ADDENDUM NO. 2

NEW GYMNASIUM ADDITION TO MONTEVALLO HIGH SCHOOL

Architect Job No. 25-33

December 8, 2025

6 INTERIOR ELEVATION • MEN A101
SCALE: 3/8" = 1'-0"

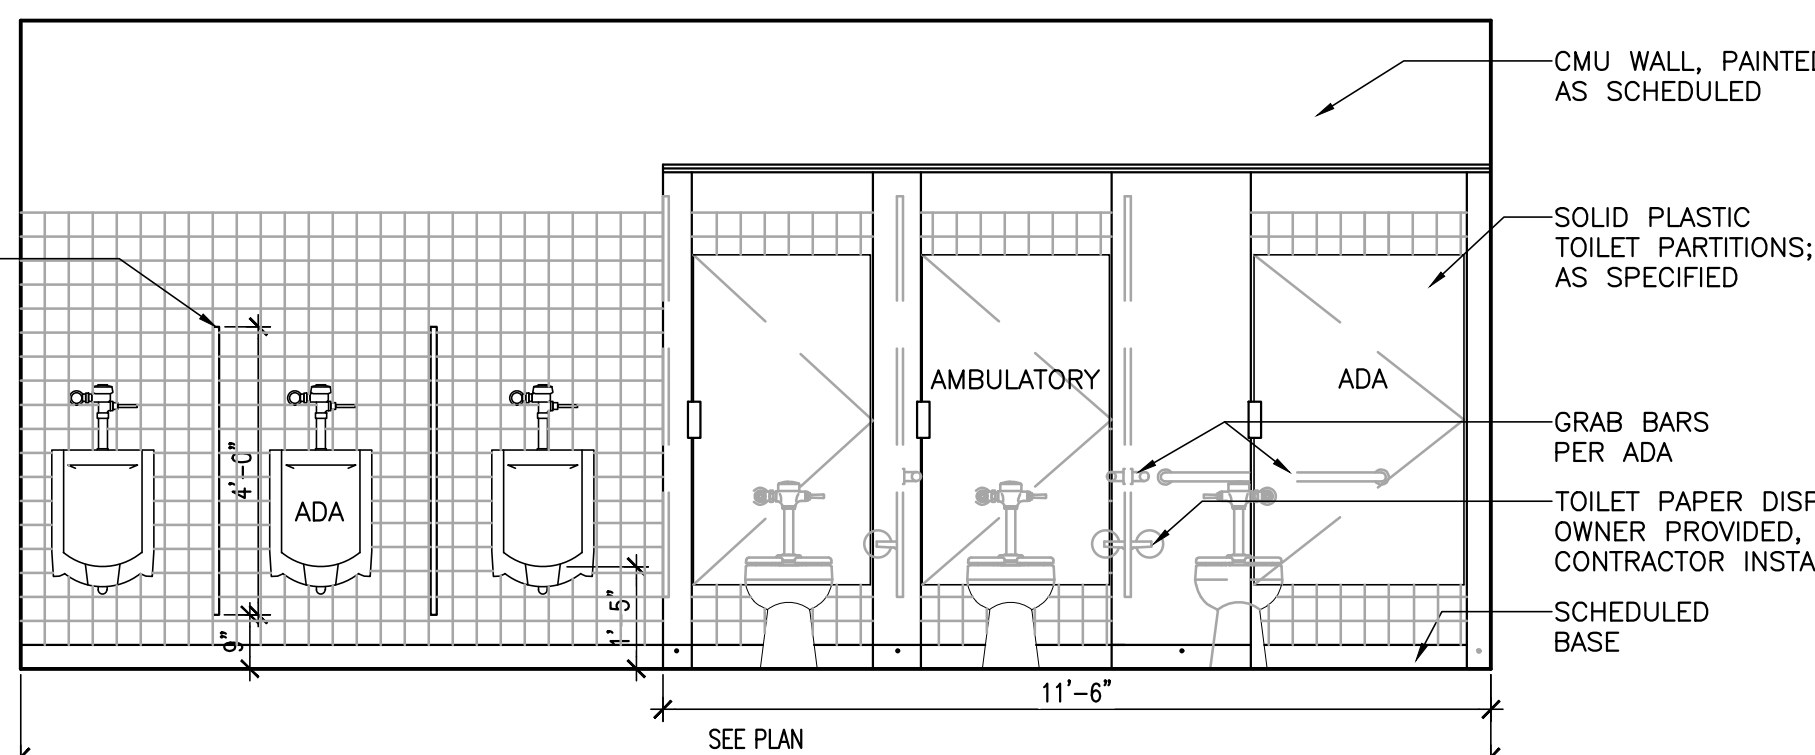
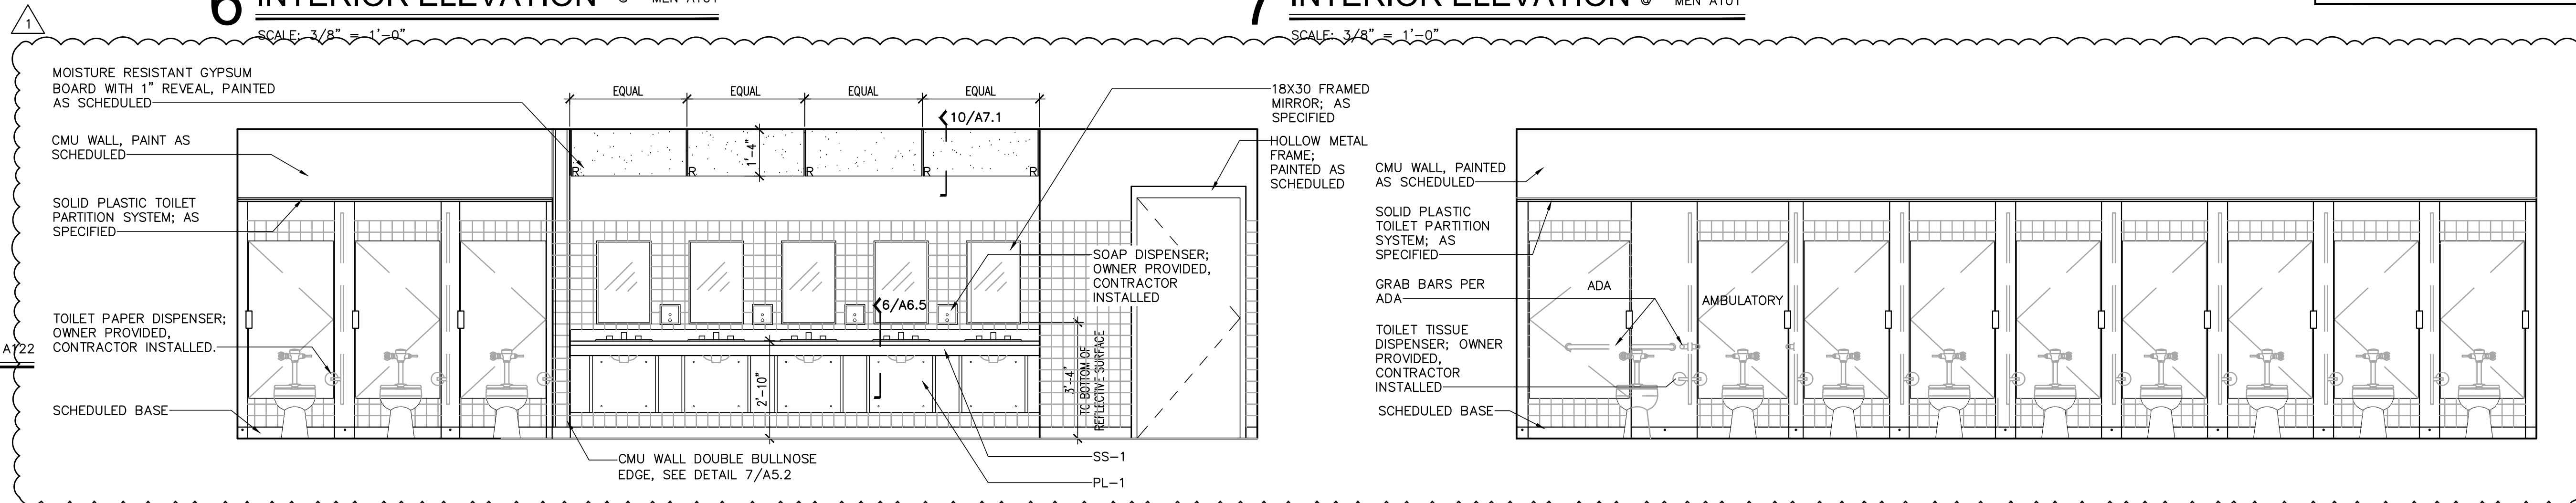
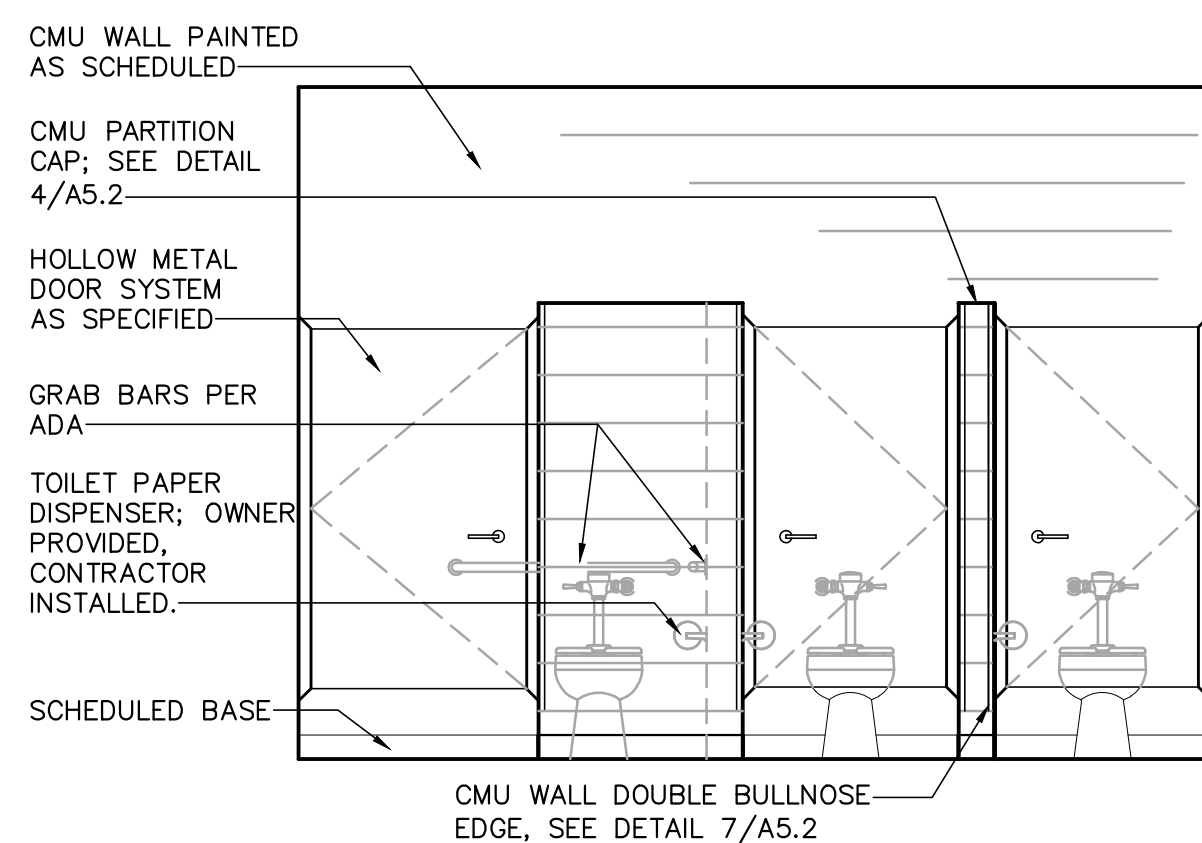
- 1. **Sheet A3.1.1** – Clarified the type of letters on the building.
- 2. **Sheet A3.3.3** – Added dimensions to the columns on sections 1 and 3.
- 3. **Sheet A5.1** – Revised Interior Elevations 6, 7, 8, & 9 – Ceramic Tile on Walls Stops at 6'-4".
- 4. **Sheet A6.4** – Revised Detail 8 – Tackable surface applied directly to plywood, as shown in Details 9 & 10.
- 5. **Sheet A8.1** – Revised Finish Floor Plan 1 – Wood gym floor types clarified.

1 FINISH FLOOR PLAN

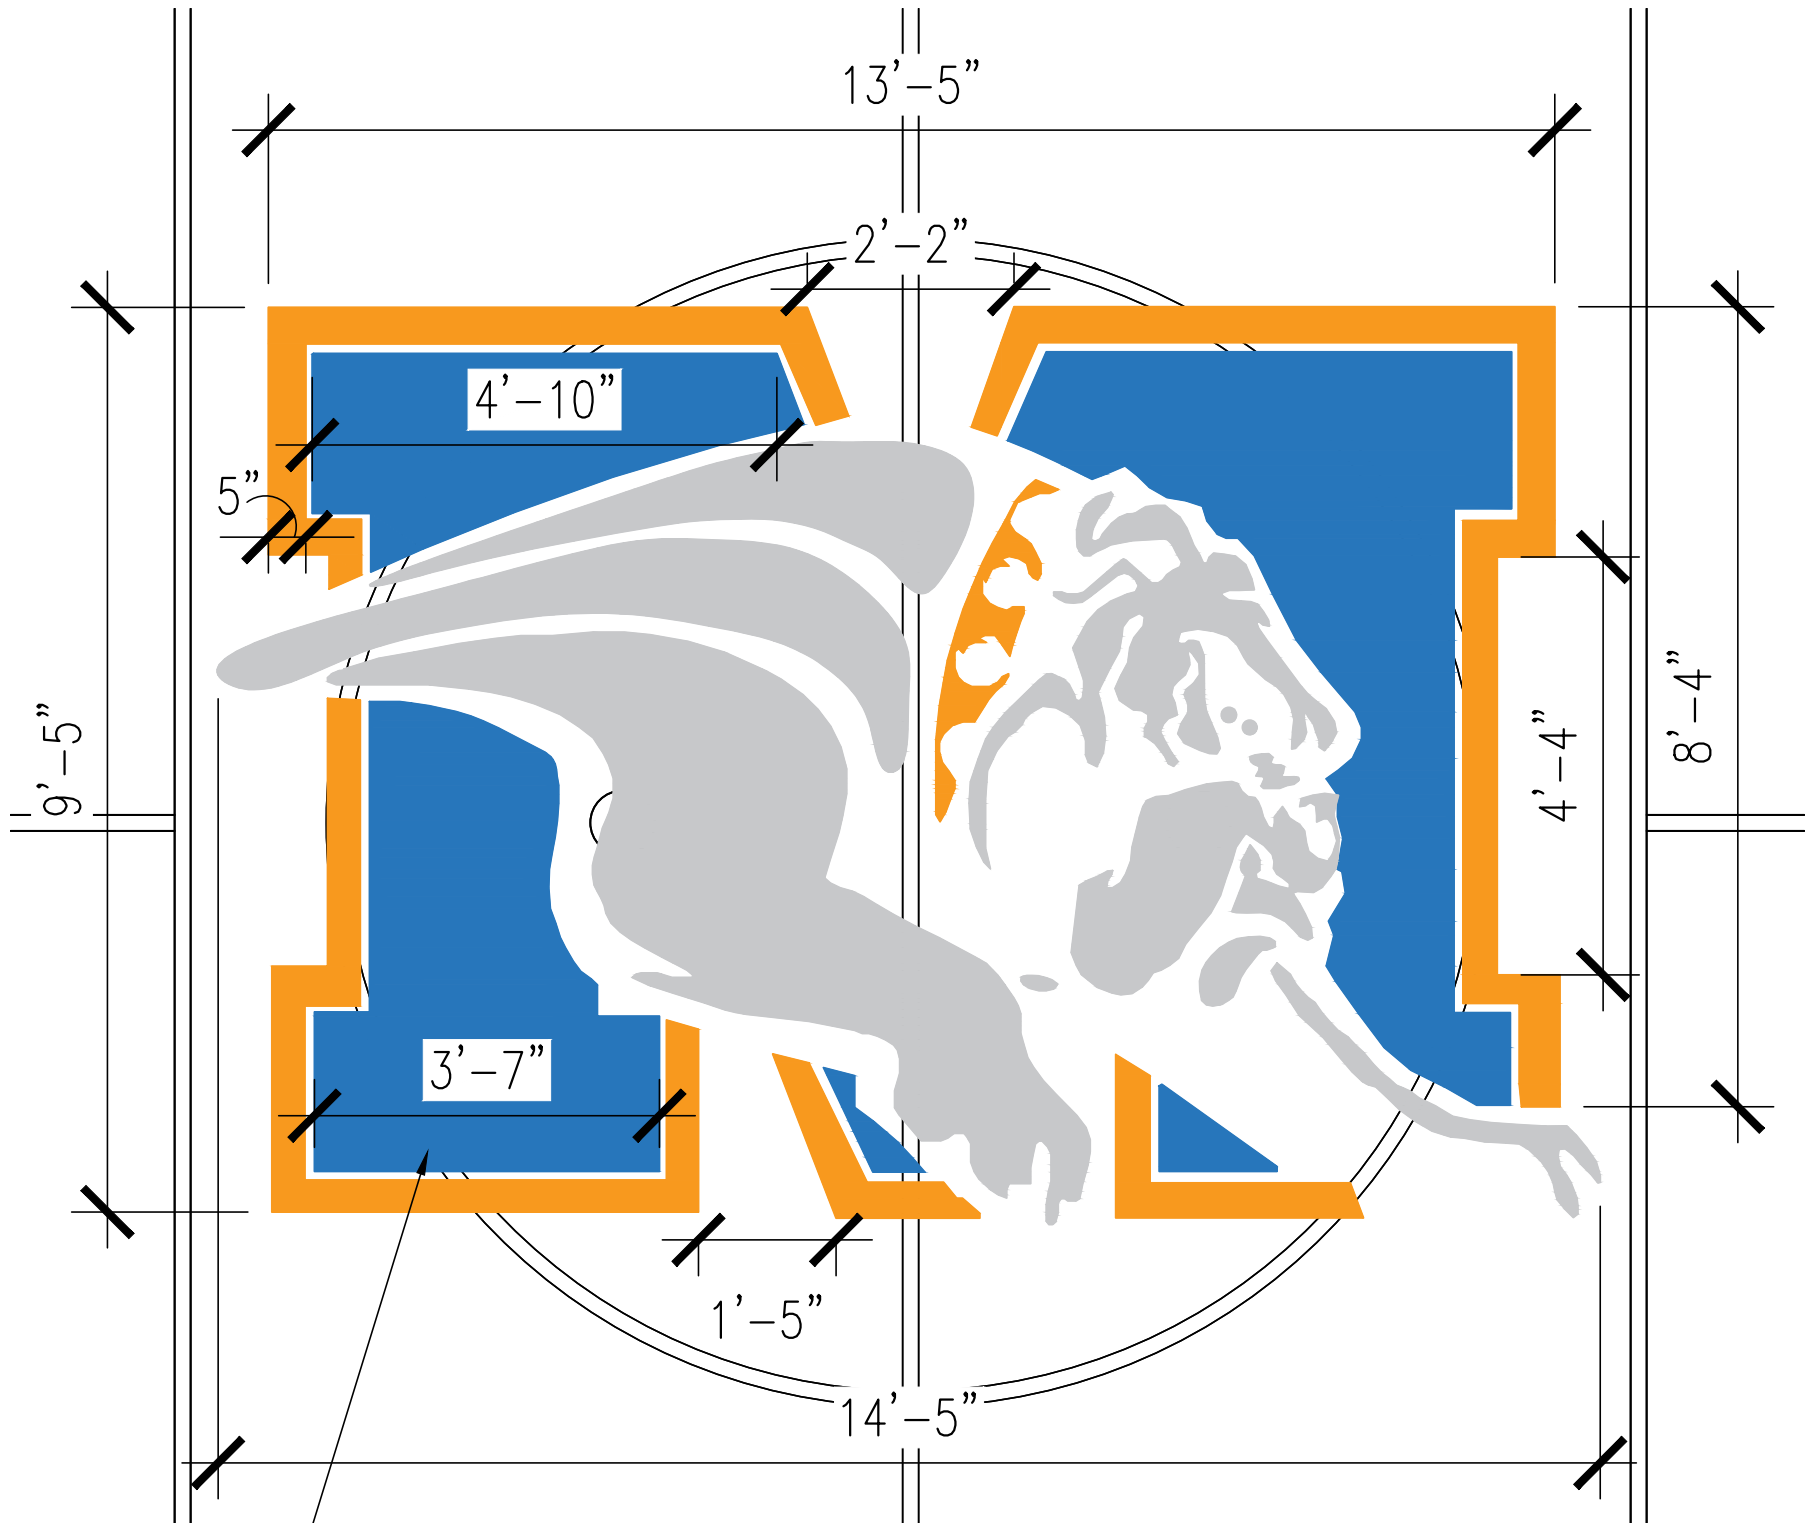
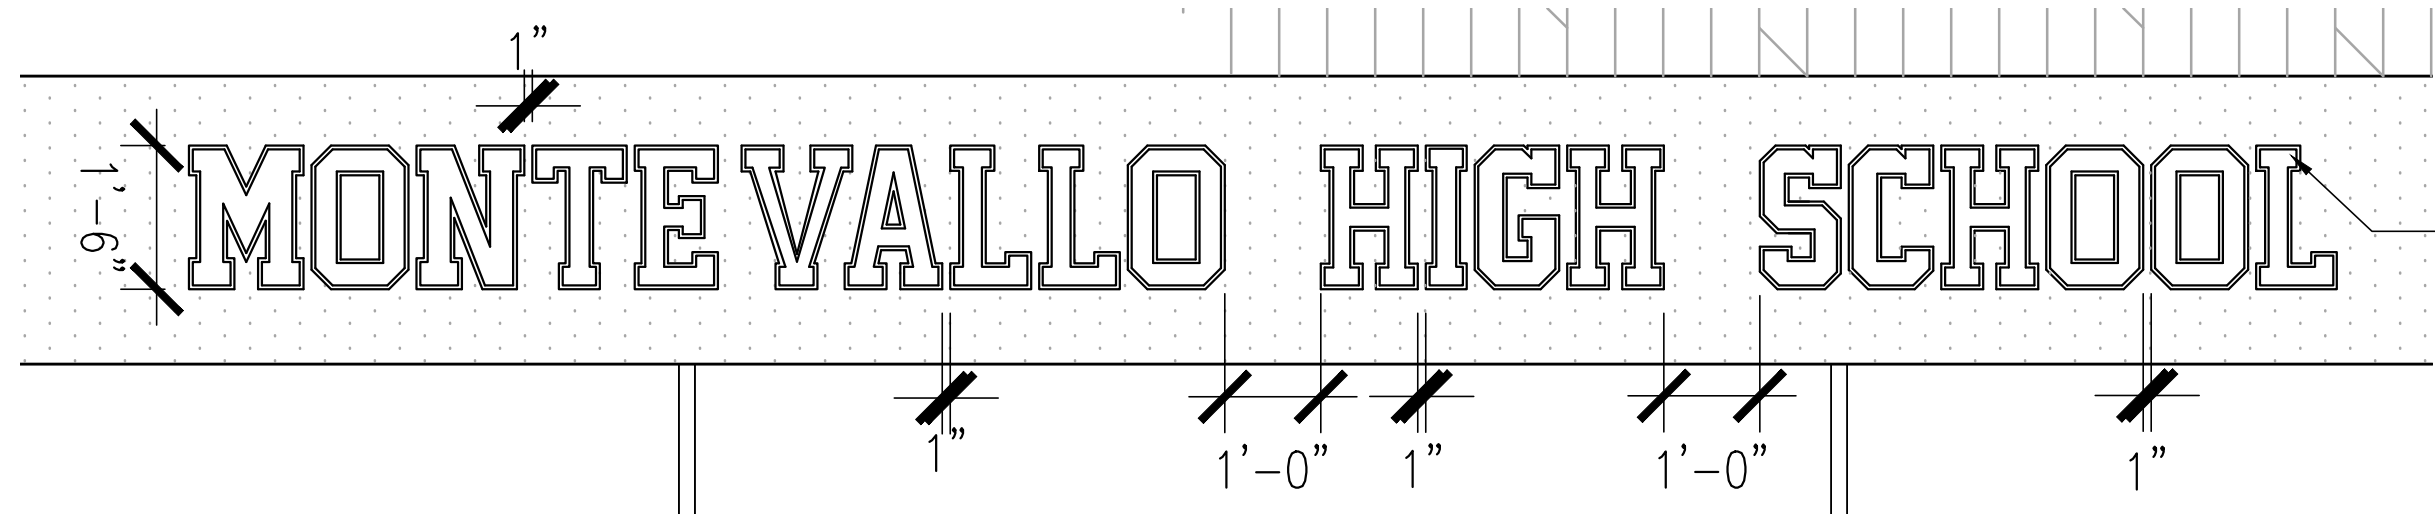
8. A103 and A108 shall both be ERF-1 Floor and Base. Lobby A125 shall be VCT-1 only with no pattern. At Trophy A104 and A106, the floor shall be VCT-1.

**1** FIRE PROTECTION - FLOOR PLAN
1/8" = 1'-0"

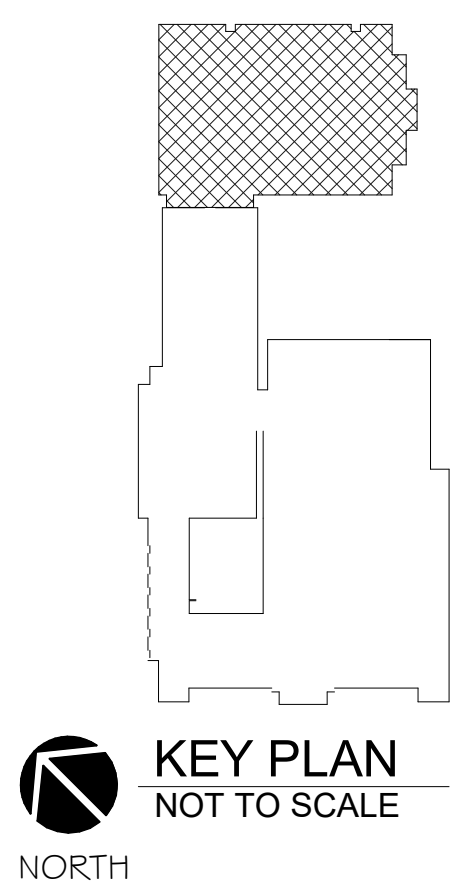
9. **Sheet FP1.0** – Revised sprinkler head locations.
10. **Sheet P0.1** – Revised washing machine specifications.
11. **Sheet P0.1** – Revised water heater and gas connection details.
